EVINRUDE

Product Service Update 2011[®]

Product Service Update

Engine Wiring Harness Change 15 – 30 HP Models

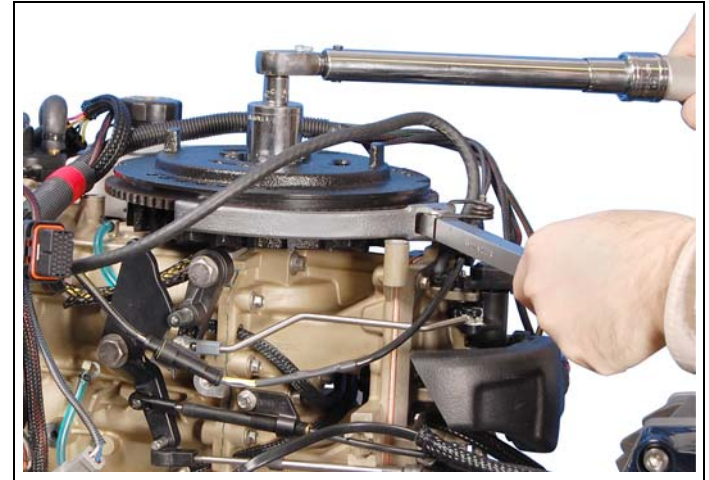
Evinrude E-TEC 15 – 30 HP (C, H, R, and S-suffix) model outboards have a new engine wiring harness to support changes to the *Touch Troll* and neutral switches.

The *Touch Troll* switch connector has been eliminated. Wiring for the *Touch Troll* switch has been relocated to a new 6-pin AMP connector of the tiller harness. The neutral switch has a dedicated 2-pin AMP connector, similar to other *Evinrude E-TEC* models.

Lower Mount 15 – 30 HP Models

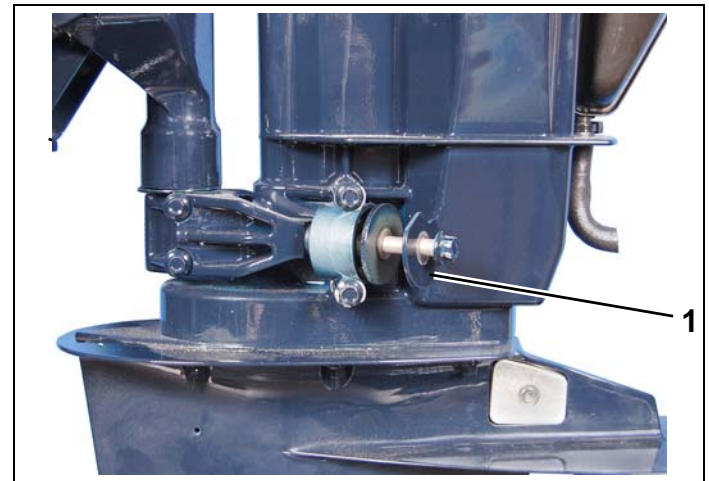
A bump stop washer, P/N 353674, was added to the lower mount on 15 – 30 HP models. This change to improves impact protection, and provides common service parts and procedures for all 15 – 30 HP models.

1. Bump stop washer

Oil Cap Assembly, 15 – 90 HP Models

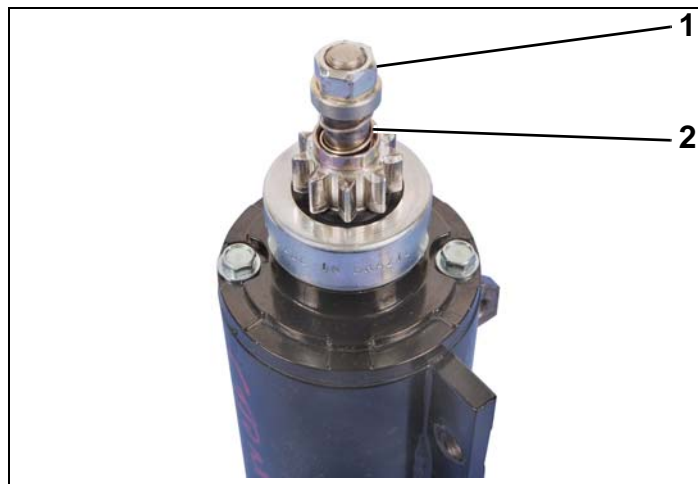
The oil cap used on 15 – 90 HP models has changed.

The oil cap has a redesigned vent valve, to help prevent oil from leaking out of the vent while the engine is tilted.

Oil cap assembly, P/N 5008406, replaces oil cap assembly, P/N 5007256, and services 2009 and newer 15 – 30 HP models and 2010 and newer 40 – 90 HP (F-suffix) models.

Electric Starter Motor Change 40 – 65 HP Models

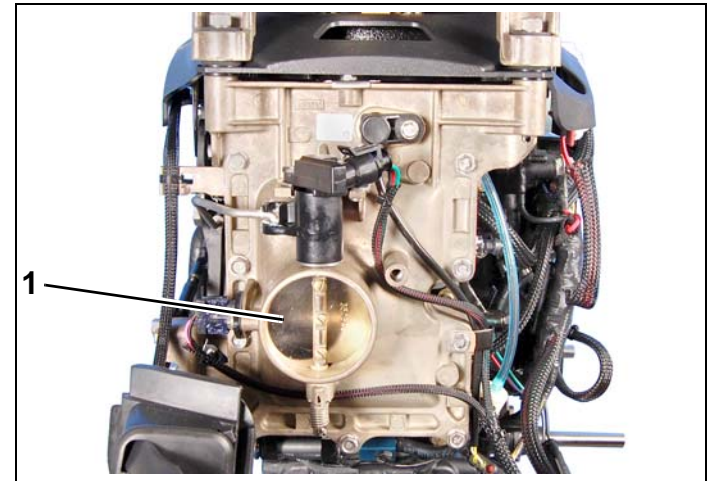
The electric starter motor used on *Evinrude E-TEC* 40 – 65 HP models has been changed.

The starter features a new nut and spring to retain the drive gear. Previously, the drive gear was retained with a clip, spring and spacers. This change improves the durability of the starter and provides common service for all 15 – 65 HP models.

The electric starter motor, P/N 587045, services all 2004 and newer 15 – 65 HP models.

Throttle Body Assembly 40 – 65 HP Models

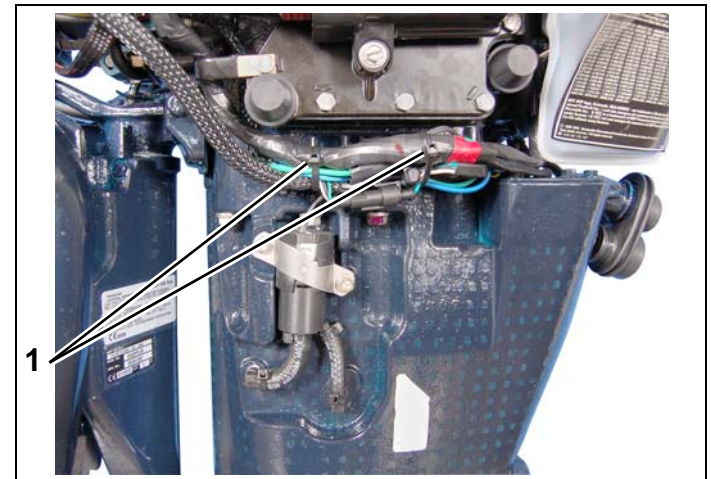
A new throttle body assembly is used on all 40 – 65 HP models.

The throttle body assembly features a nickel-plated throttle valve, which improves corrosion resistance and durability. The new throttle valve is silver in color, while the previous throttle valve was gold in color.

The new throttle body assembly, P/N 5008407, services all 2004 and newer 40 – 65 HP models.

Exhaust Housings 40 – 65 HP Models

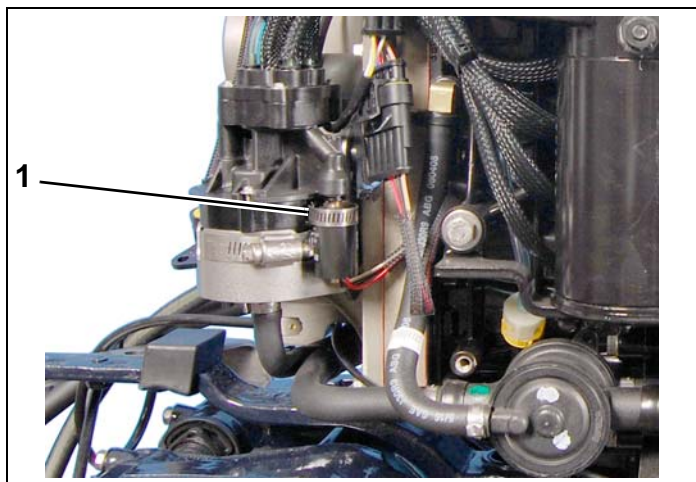
A change was made to the exhaust housing for 40 – 65 HP models.

Retainer tabs have been added to the exhaust housing to better secure the engine wiring harness. Tie straps are now used to secure the engine wiring harness, rather than the previous “J-clamps.”

Exhaust housing, P/N 5008275, services 2006 and newer 40 – 50 HP models.

Exhaust housing, P/N 5008274, services 2006 and newer 60 – 65 HP models.

Oil Pressure Sensor 115 – 300 HP Models

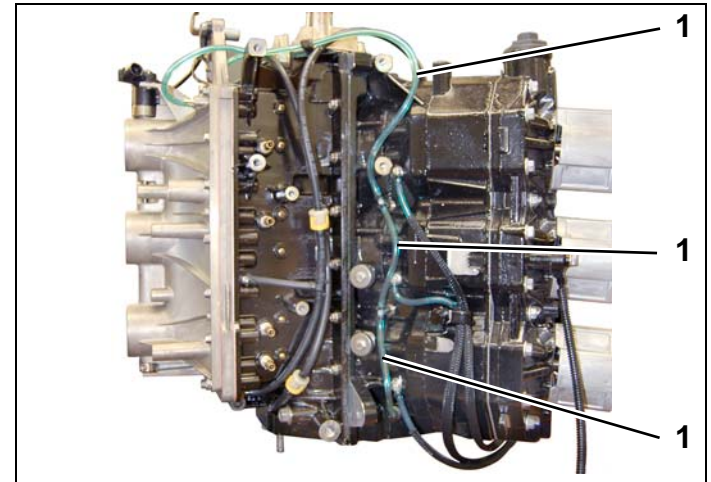
Clamp, P/N 982115, is now used to retain the oil pressure sensor to the oil pump housing on all V4 and V6 models.

This change improves the retention of the oil pressure sensor and provides common service parts for these models.

Shift Switch 200 – 300 HP 90° V6 Models

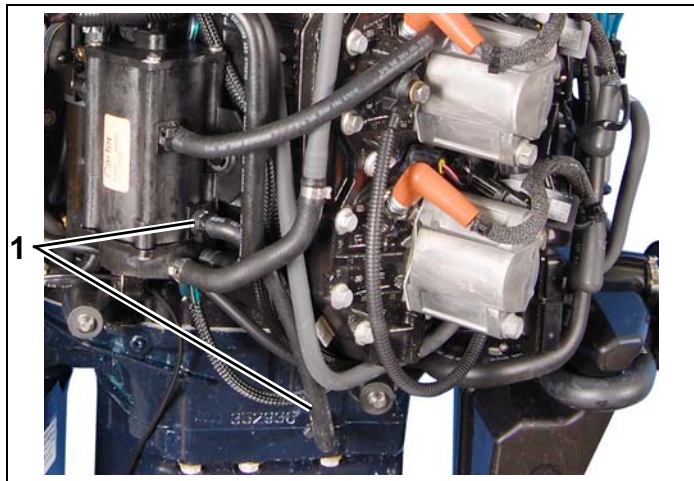
Shift switch, P/N 586861, has been relocated from the shift linkage to the cylinder and crankcase. This change improves the operation of the shift switch.

Cooling System Change 250 – 300 HP 90° V6 (3.4 L) Models

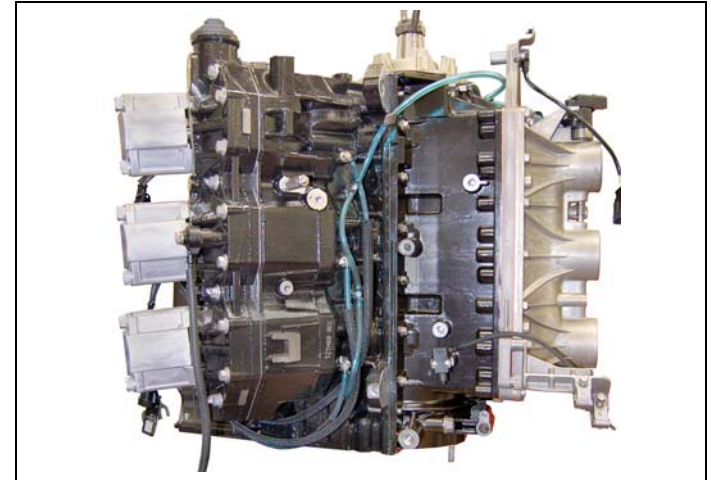
The cooling water hose from the vapor separator outlet to the exhaust adapter has been relocated to the exhaust emission test port of the exhaust adapter.

This change improves water pressure to the powerhead and provides additional water to cool the propeller hub.
